139 VALVE

607.3301

Part Name: Valve Pull Force Test Tool

WORK ORDER NON-CONFORMANCE / ROUTE UPDATE

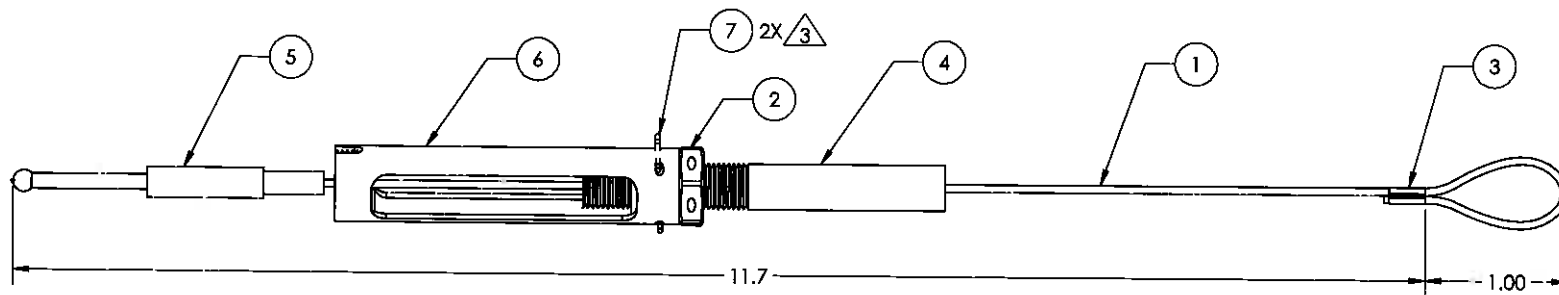
We measure the CBL-1240 Cable we have in stock and we will not deviate the 645.7810 Cable Rod.

The diameter of the uncoated Cable was 0.063".

We would like to make changes to the following P/Ns in order to decrease the lead time for the 607.3301 Valve Pull Force Test Tool

607.3301 Valve Pull Force Test Tool

- Replace 601.1581 Cable with CBL-1240
- Replace 601.1054 Crimp Sleeve with CBL-460
- Replace 601.2330 Cotter Pin with MS24665-103

650.7910 Shroud

- Omit outsourcing for Passivation

645.7910 Cable Housing

- Omit outsourcing for Passivation

645.7110 Lock Nut Swivel Type

- Omit outsourcing for Electropolish and Passivation.

Per our conversation these deviations are acceptable.
